UNITED STATES FISH AND WILDLIFE SERVICE

ENVIRONMENTAL ACTION STATEMENT

TO: SBSP Project Management Team
FROM: SBSP Consultant Team
DATE: July 11, 2011
RE: **Recommended Approach for NEPA/CEQA Compliance for the Revised Design of Phase 1 Actions at Ponds A16 and A17**

To:	Eric Mruz (USFWS)	Project:	Design/Build of Ponds A16 and A17 on the Don Edwards San Francisco Bay NWR
Prepared by:	Greg Allington (McMillen)	Cc:	Jim Burby (USFWS) Eric Mruz (USFWS) Mendel Stewart (USFWS) Melissa Helton (USFWS) John Bourgeois (CSCC) Dan Axness, PE (McMillen)
Approved by:	Mort McMillen, PE (McMillen)		
Date:	August 18, 2011	Contract No:	F11PD00552
Subject:	Alviso Pond A16-A17 Restoration Design Modification Implications to Existing Environmental Permits

*Alviso Pond A16/17 Restoration
Revised 30% Design*

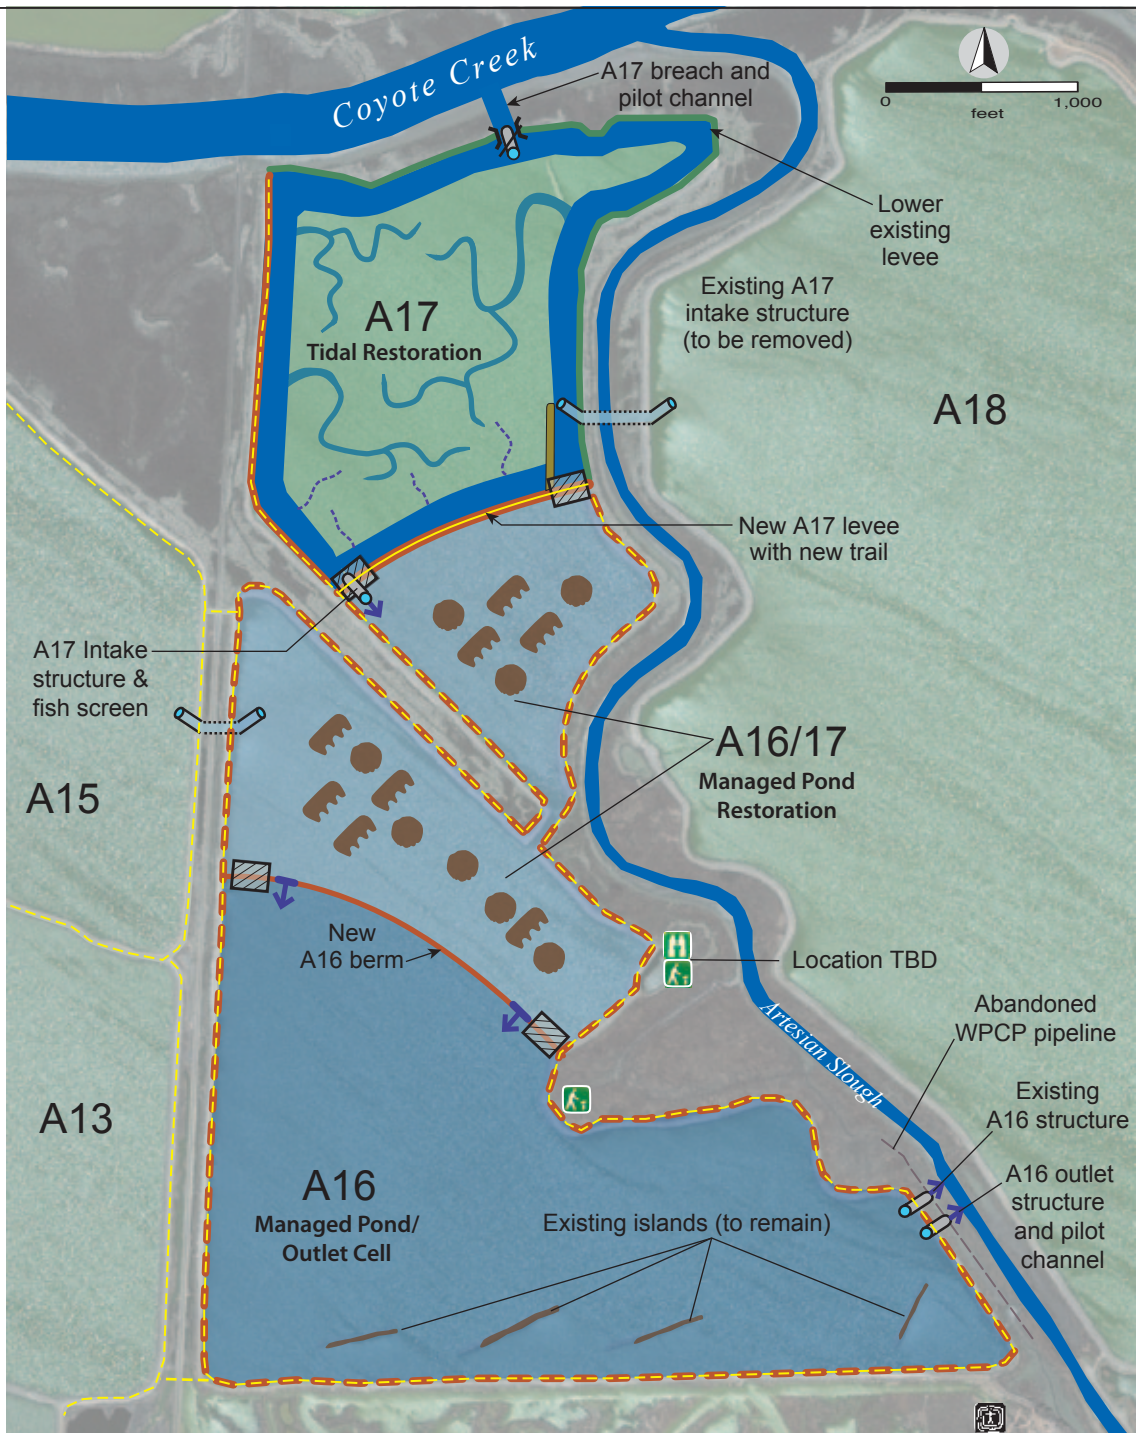
The revised concept (**Figure 2**) extends the managed pond restoration into the southern part of Pond A17, reintroduces full tidal inundation to the northern part of Pond A17, and eliminates earthwork and construction in the deeper, southern part of Pond A16. The revised concept has only one managed cell with new islands, compared to three managed cells in the original design. The managed cell areas of Ponds A16 and A17 are connected by an existing open channel between the ponds. A new levee would be constructed to separate the tidal part of Pond A17 from the combined A16/17 managed cell. The southern, remaining part of Pond A16 would be separated from the managed cell by a berm. The southern part of Pond A16 is expected to have some managed pond value, but would not fully conform to the reconfigured managed pond restoration design criteria.

The revised design decreases the area of managed pond habitat from 150 acres previously to 60 acres for the revised concept. The number of nesting islands would decrease from 50 to 16. Approximately 90 acres of new tidal habitat would be created in Pond A17.

Figure 1. 50-Year Long Term Goal for Pond A17

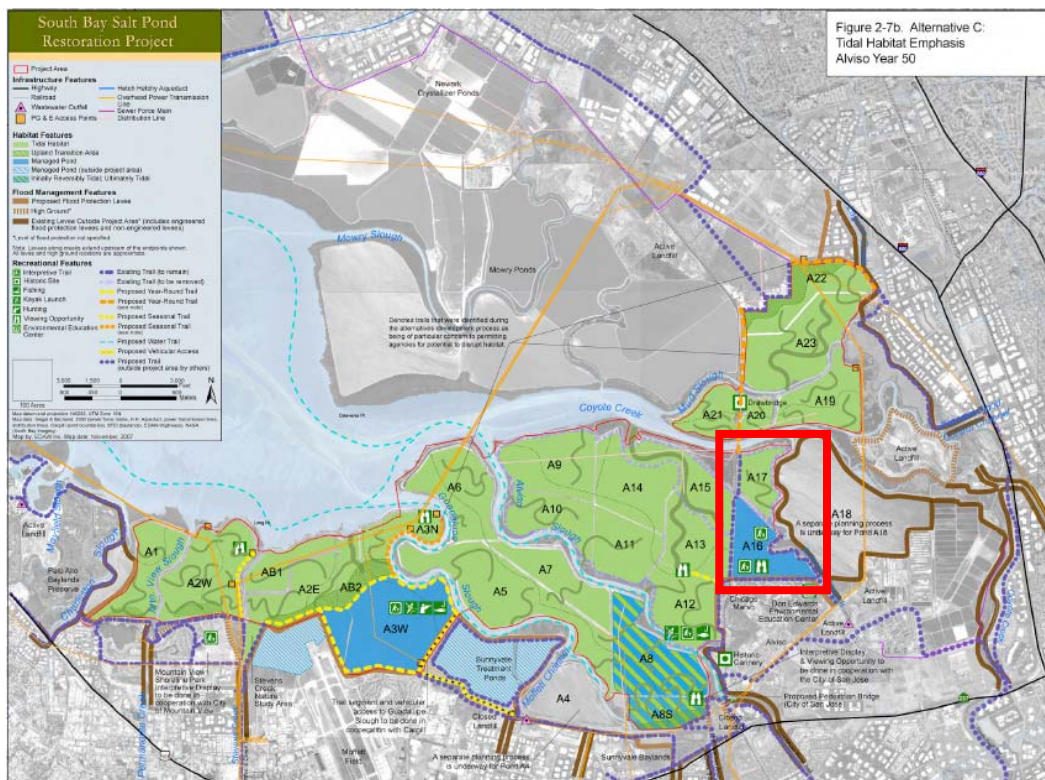
The levee breach and structure removal at the inlet of Pond A17 from Coyote Creek is not permitted under existing permit approvals. Permit approvals state that the existing structure is to remain in place with a new fish screen installed and there is no approval for a complete levee breach in any location in Pond A17. By breaching the existing intake structure, it eliminates the need for a second intake structure. As a result, there would be no impacts to the salt marsh habitat on the northern side of Pond A17 levee.

Lowering of the levee along the northern, eastern and southern portions of Pond A17 is not permitted under the existing permit approvals. Permit approvals state that the only source of water entering Pond A17 is through the new and existing intake structures that would both require fish screens. However, the 50-year goal for Pond A17 according to the selected alternative (Alternative C) shown on Figure 2-7b in the Final Environmental Impact Statement/Report is to restore it to tidal habitat (Figure 1). The permit approvals do not approve this levee breaching and lowering; however, the intended use does meet the criteria of the 50-year long-term objective for this project.

Since the levee lowering is not approved under existing permit approvals, McMillen is proposing to perform this construction element during Phase 2. Phase 2 would excavate the entire levee down to approximately MHW which would allow high tides to enter Pond A17. This construction action is not approved under existing permits and may require additional permitting.
